66321B-08 ERVICE S ΝΟΤΕ

66321B - MOBILE COMMUNICATION DC SOURCE, **15V/3A WITH BATTERY EMULATION. GPIB**

Serial Numbers: MY43003160 – MY43003330 SG43003160 – SG43003330

Power-On Self test Errors, Auto reboot, Blank display. No output Communication errors. No communication when using the GPIB Interface.

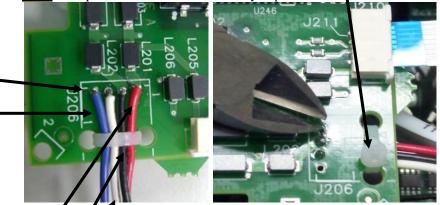
The instrument will exhibit the defects described above when the primary 5 volts drops below the design limits described. Poor crimping of the female connectors on the bias cable is the cause of the problem. The pictures below show in detail the female connectors having the problem.

Remove the connector P/N 1252-3695 (circuit reference) "J206" on the "A2" interface assembly. When removing "J206" care should be taken not to damage the "A2" printed circuit board material or the circuit board traces. "J206" has 4 holes remove the solder from these holes as shown. Do not apply too much heat or pressure this may cause damage to the PCA

Remove the pins from the connector housing as shown. Cut 3cm off the clear tubing of the cable

Cut the crimped terminals at the crimp around the wires colored insulation. This is done so the cable length can be as long as possible a short cable may cause assembly issues.

Each wire in the cable should be striped to 5mm. CAUSION: Inspect each wire for defects such as cut strands and damaged insulation,

Insert the cable into the open holes located on the "A2" GPIB interface assembly. Depending on the model there may be three or four wires. Inspect the wires on the top and bottom of the "A2" GPIB interface assembly. Inspect for the following defects:

- 1. Cold solder joints top and bottom of the assembly
- 2. Good solder fillets on the top and bottom of the assembly
- 3. Insure that all of the wire strands are in the holes provided and there are no shorts of solder or wire strands between each wire when soldered into the "A2" GPIB interface assembly.
- 4. Trim the lead make sure they are not over cut and no excessive leads are left.
- 5. Make sure that the instrument is clean of solder and wire strands and loose wires.
- 6. A Wide Nylon cable tie is required as shown to support the wires after the up-grade has been completed. Cut the excess Nylon of as shown.

Note the sequence of the cable wires is very important!

The **Red** wire is soldered in the main control board (reference E320) and should be soldered into pin #1 or the square pair of "J206" on the "A2" interface assembly.

The **Black** wire is soldered in the main control board (reference E324) wire should be soldered into pin #2 of "J206" on the "A2" interface assembly.

The White wire is soldered in the main control board (reference E321) should be soldered into pin #3 of "J206" on the "A2" interface assembly.

The **Blue** wire is required for the models shown below **ONLY.** This **Blue** wire comes from the connector on the battery emulation board P/N 5064-0131 circuit reference J001 Pin 12, the **Blue** should be soldered into pin # 4 of "J206" for the models listed below only. All other **66300X Mobile Comm DC Sources** only require 3 wires.
